Product Change Notification

MultiTech Conduit® Gateway
MultiTech Conduit® IP67 Base Station
MultiTech Conduit® IP67 200 Series Base Station
MultiTech Conduit® AP Access Point

mPower™ Edge Intelligence Update
mPower 6.3.4 Now Available

Product Change Notification (PCN) Number
PCN 04092024-002

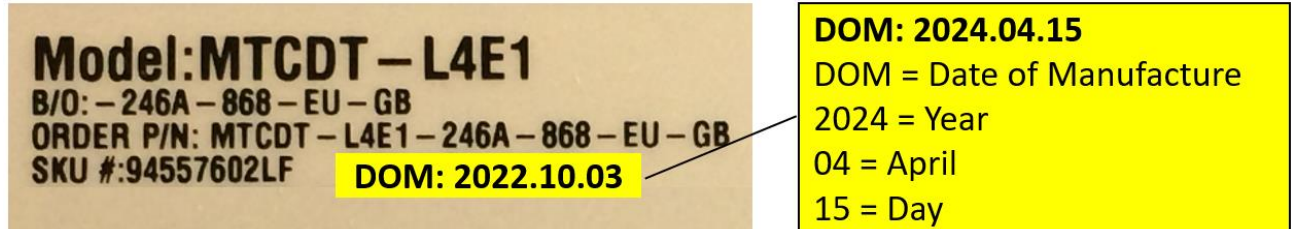
- DeviceHQ® Cloud-Based Device Management
 - In previous versions of mPower, DeviceHQ incorrectly reported the version of mPower installed on the device
 - In mPower 6.3.4, this behavior has been corrected
